Access Compliance Report

Public Rights-of-Way

Intersection ID: 31509	Main Street: CARLEEN_WAY_DR	Cross Street: WILGROVE_WAY_DR	Location: S
ADA ID: EEFC7126D828	Ramp Type: PerpDiag	Initial Pass/Fail: Fail	Overall Compliance: No
		Severity Score: 30

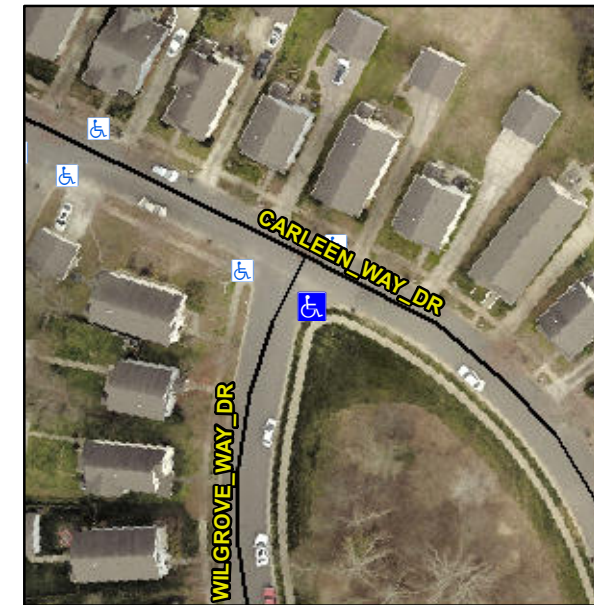
Not Found, R304.5.1, R304.2.2

Compliance	Description	Data	Compliance	Description	Data
N/A	Ramp Length (in)	45.0	No	Ramp Slope (%)	8.9
No	Ramp Width (in)	32.0	Yes	Ramp XSlope (%)	0.3
N/A	Flare Type LT	N/A	N/A	Flare Type RT	N/A
N/A	Flare Slope LT (%)	N/A	N/A	Flare Slope RT (%)	N/A
N/A	Flare Traversable LT?	N/A	N/A	Flare Traversable RT?	N/A
N/A	Landing Length (in)	N/A	N/A	DWS Provided?	N/A
N/A	Landing Width (in)	N/A	N/A	DWS Contrast?	N/A
N/A	Landing Slope (%)	N/A	N/A	DWS Length (in)	N/A
N/A	Landing X Slope (%)	N/A	N/A	DWS Full Width?	N/A
N/A	Landing Curb? (Y/N)	N/A	N/A	DWS Offset (in)	N/A
N/A	Shared Landing?	N/A			
N/A	Gutter Ponding?	N/A	N/A	Gutter Slope (%)	N/A
N/A	Gutter Lip Ht (in)	N/A	N/A	Gutter X Slope (%)	N/A
N/A	Painted X Walk1?	No	N/A	Painted X Walk2?	No
	X Walk 1 Direction	To NE		X Walk 2 Direction	To NW
N/A	X Walk 1 Width (in)	N/A	N/A	X Walk 2 Width (in)	N/A
	X Walk 1 Slope (%)	0.8		X Walk 2 Slope (%)	2.0
	X Walk 1 X Slope (%)	1.3		X Walk 2 X Slope (%)	0.1

Remove & Replace Curb Ramp With Two New Directional Ramps or Equivalent.
